## Walkable Midtown: The Midtown-St. Albans Area Plan

Planning Commission  
Committee of the Whole  
Oct. 22, 2020

# Status Update

# Waterfront District: Height at north end of Industrial (CP-2A-20)

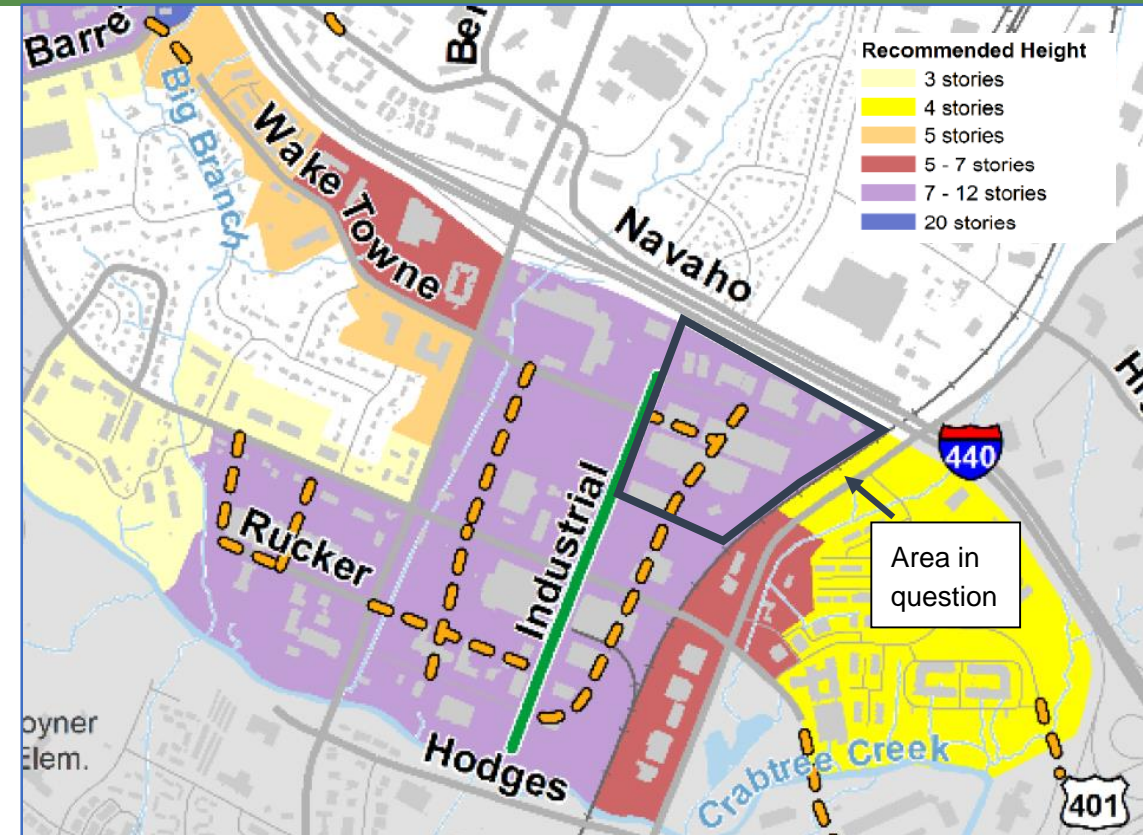
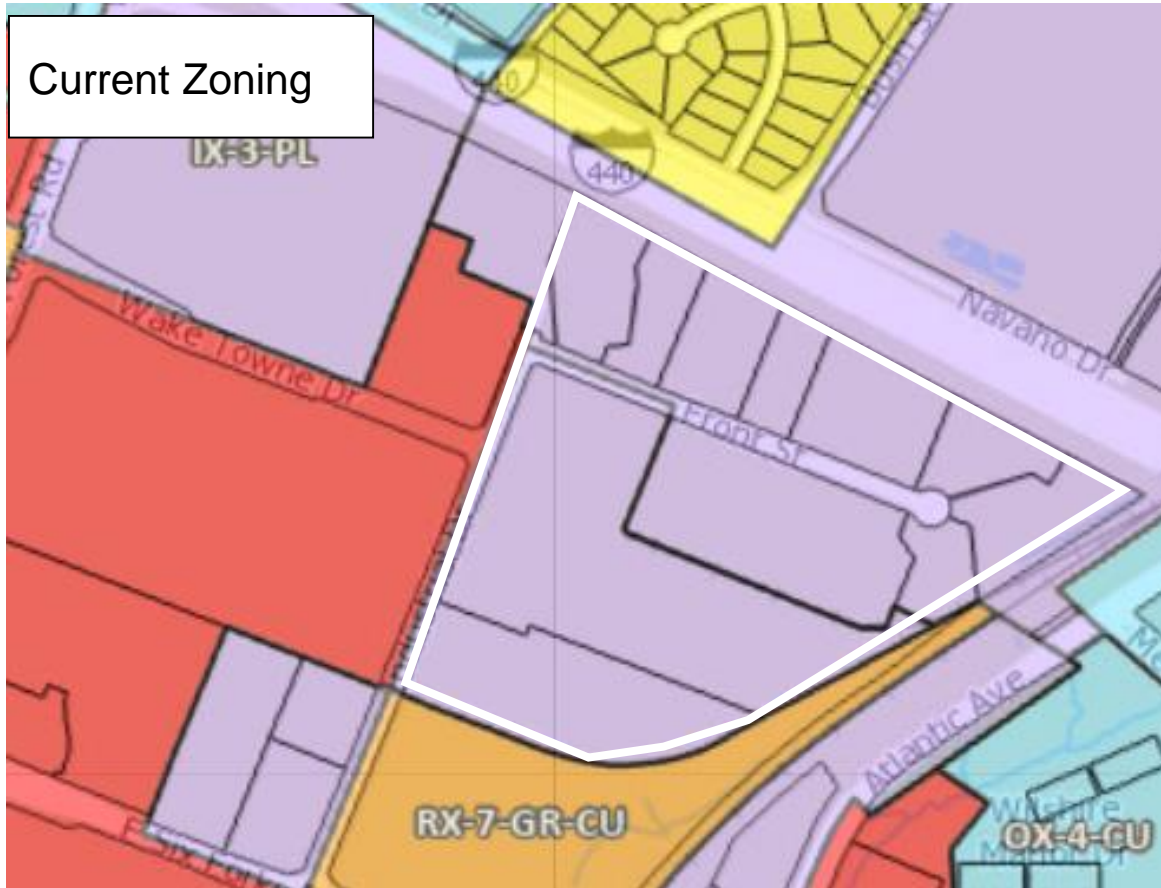
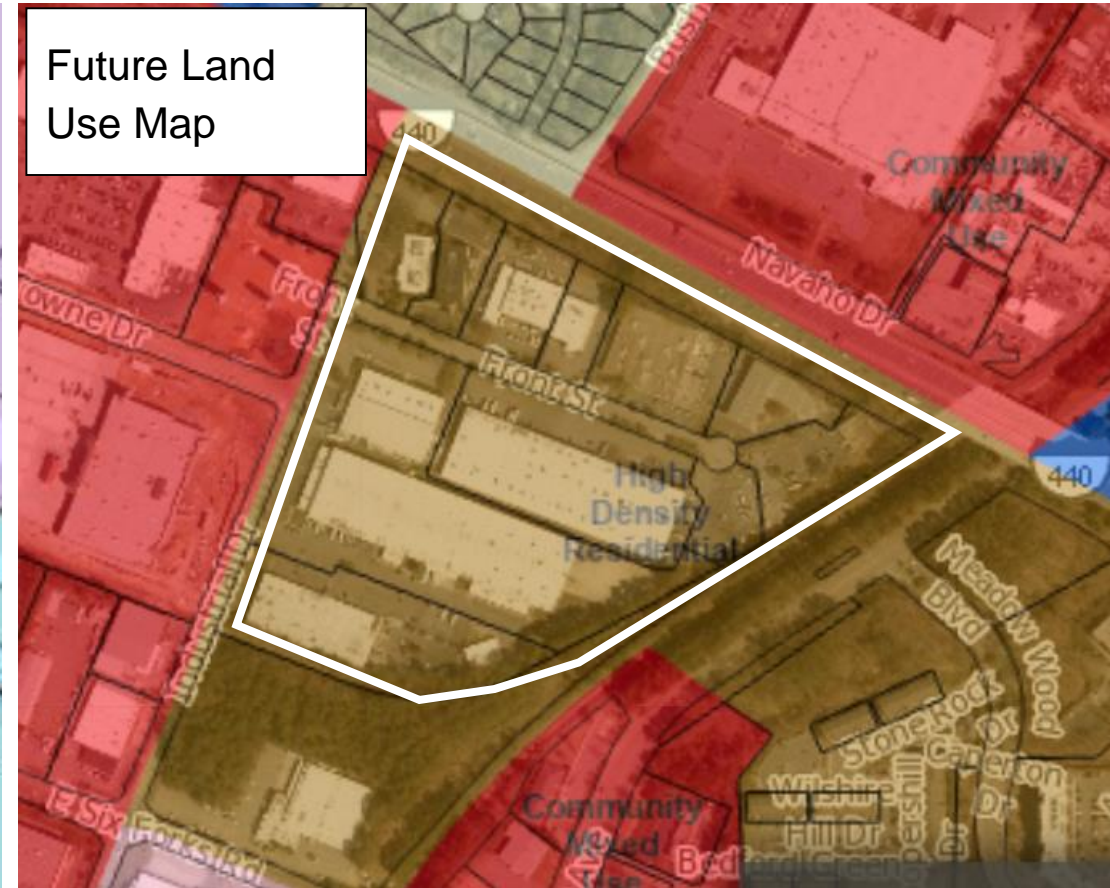
**Comment:** More height (20 stories) should be allowed in Industrial/Front area. Plan recommends up to 12.

1. Retain Plan recommendation of 12 stories (existing general height guidance in either the High Density Residential or Community Mixed Use categories also is up to 12 stories). This reflects the plan recommendation for allowing more housing and employment options in the area.
2. Revise plan recommendation to 20 stories. Additional height beyond that explored by the plan process or current height guidance ideally should involve a new process. Any property owner or resident may request a FLUM change.

# Waterfront District: Street Plan at north end of Industrial (CP-2D-20)

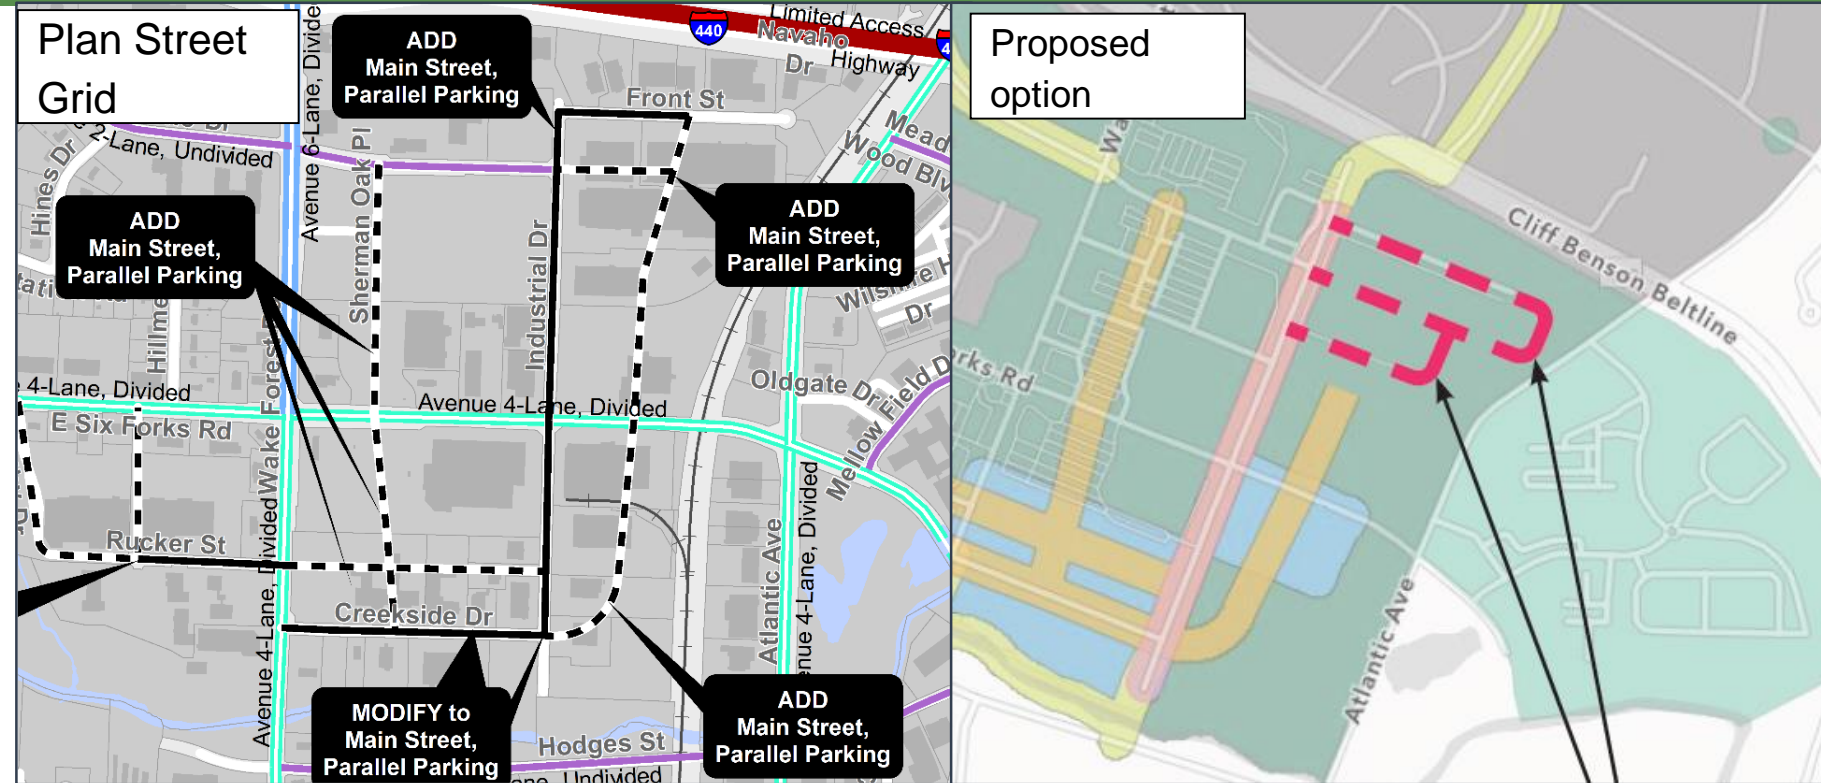
Amend street plan recommendation at Industrial/Front  
**Plan principle:** A connected grid is essential for walkability

1. Accept alternate proposal, with provision that it connects to the Creekside Drive extension. This meets the overall goals of the Street Plan recommendation. This addresses a portion of the comment and still aligns with the plan recommendation for walkability in this area, which is enhanced by adding to the street density.
2. Retain existing proposal. This reflects with the plan recommendation for walkability in this area, which is enhanced by adding to the street density.
3. Accept alternate proposal. This addresses the comment but does not meet the goals of the Street Plan recommendation, as it forces all southbound and eastbound trips onto Industrial Drive.
